83-97 HIGH STREET

ZONING LOCATION 12-3 PORTLAND, MAINE, July 23, 1979

A.P.-93-97 High Street
August 18, 1965

Check of plans filed with application for permit for changing use of building at the above named location from headquarters of a social service organization to classrooms for the Portland Society of Art discloses variances from and questions as to compliance with Building Code requirements as follows:

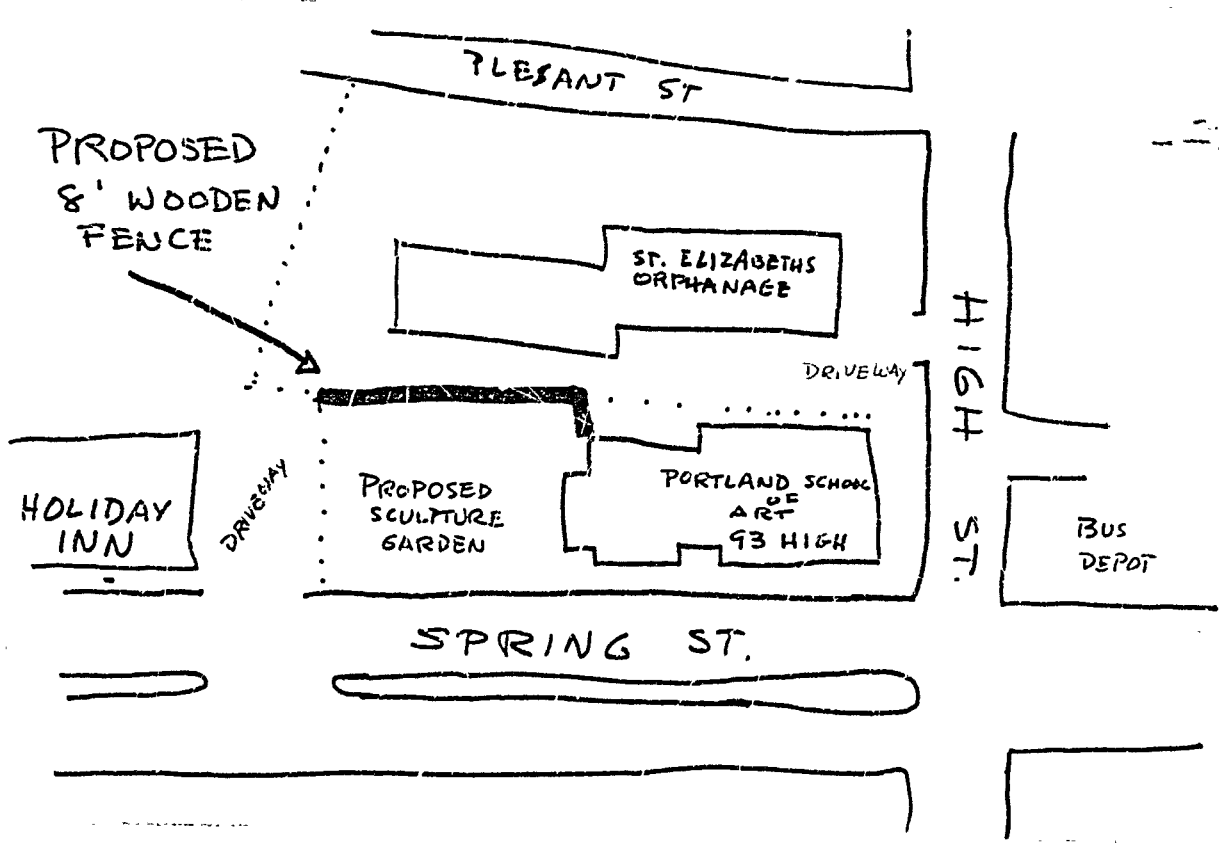
Enclosed is a sketch of the proposed
eight foot (8') fence I discussed with you on
the phone last week.

Would appreciate your opinion as I am
not too sure of the whats and wheres.

In response to your note of August 31st and enclosed sketch of the proposed 6' wood fence, it involves no problem as far as the Zoning Ordinance is concerned as long as it is at least 25' back from the edge of the sidewalk line which I assume it is. Good fencing.
